HISTORIC AND DESIGN REVIEW COMMISSION

November 15, 2017

HDRC CASE NO: 2017-567
ADDRESS: 729 N PINE ST
LEGAL DESCRIPTION: NCB 549 BLK 9 LOT S 10 FT OF ARB A 13 & N 40 FT OF ARB A 12
ZONING: RM-6
CITY COUNCIL DIST.: 2
DISTRICT: Dignowity Hill Historic District
APPLICANT: Aaron Morosini
OWNER: Jason Conine
TYPE OF WORK: Remove ribbon driveway and install roadbase/decomposed granite
APPLICATION RECEIVED: October 27, 2017
60-DAY REVIEW: December 26, 2017

The applicant is requesting a Certificate of Appropriateness for approval to remove the existing concrete ribbon driveway to install a roadbase and decomposed granite driveway.

House
729 N. Pine
Lot

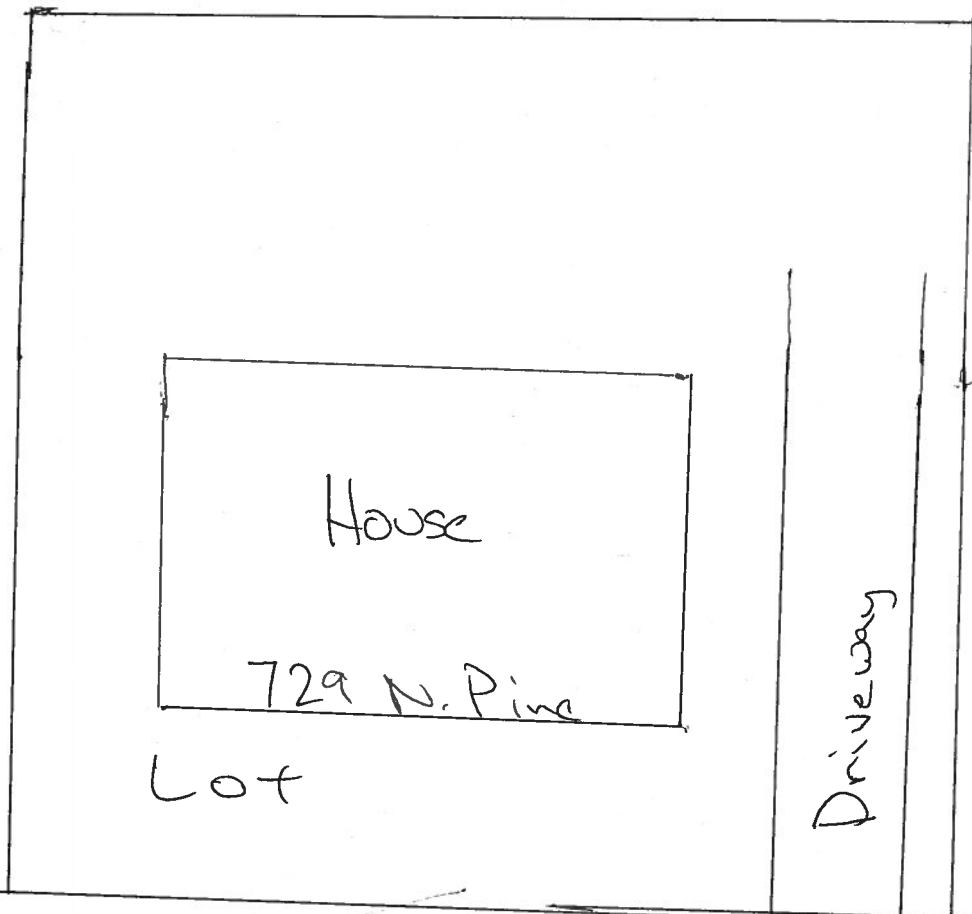
- b. The applicant has proposed to remove the existing concrete ribbon driveway to install a new driveway featuring roadbase and decomposed granite. The Guidelines for Site Elements notes that driveway configurations – material, width, and design – must be retained or repaired on historic properties, while pervious paving surfaces may be considered where replacement is necessary to increase stormwater filtration. The ribbon configuration is present on 8 of the 10 applicable properties on the N Pine Block between cross streets Nolan and Burnet; the other two driveways feature gravel and concrete. Staff does find the proposal to remove the ribbon configuration consistent with the Guidelines. Pervious paving can be considered for the center strip of grass between the concrete ribbons.

Staff does not recommend approval to remove the concrete ribbon driveway based on finding b. Pervious paving or gravel may be considered for the center strip of grass between the concrete ribbons.
